DESIGN REVIEW BOARD

DRB22-00337

To allow for the development of an industrial park

- North of Pecos Road
- East of Ellsworth Road

Building A Elevations

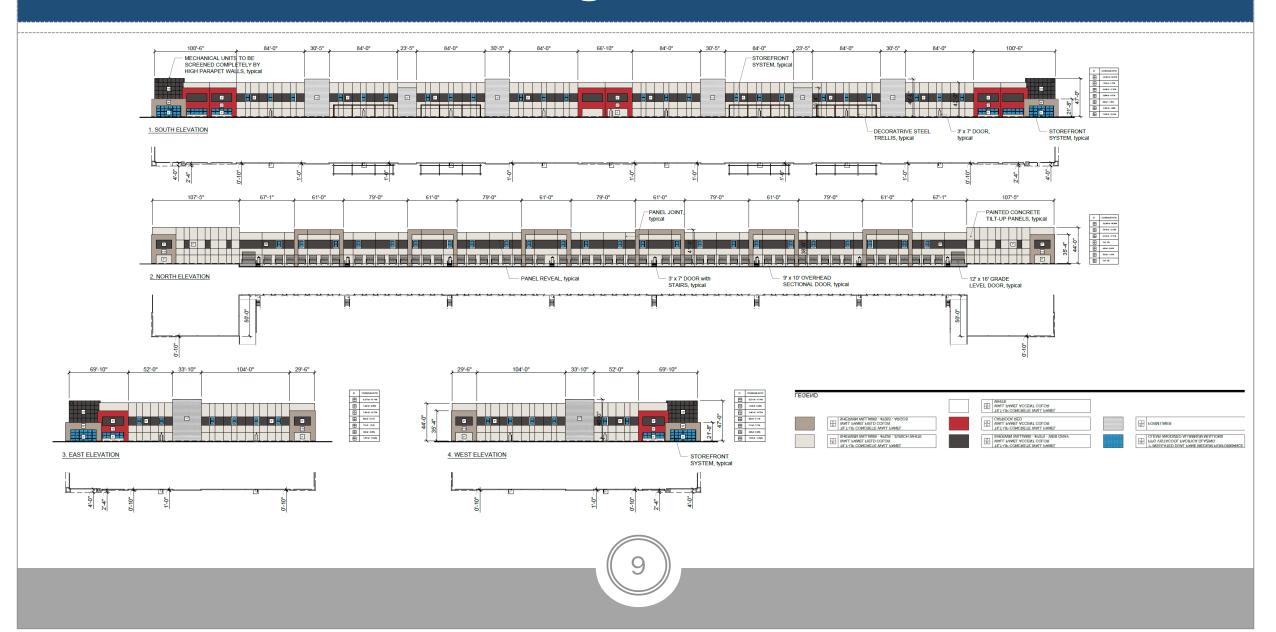
Publicly visible facades (i.e., viewed from rights-of-way or private property), may not have blank, uninterrupted wall lengths exceeding 50-feet without including at least two (2) of the following: change in plane, change in texture or masonry pattern, windows, trellis with vines, or an equivalent element that subdivides the wall into human scale proportions.

All parapets must have detailing

Facades shall incorporate 3 different materials

No more than 50% of façade may be covered in one material

Alternative Compliance

Vary building height, providing at least two (2) changes in height or roof forms that are varied over different portions of the building through changes in pitch, plane, and orientation.

Primary entrances along major facades shall be clearly defined with façade variations, porticos, roof variations, recesses or projections, or other integral building forms.
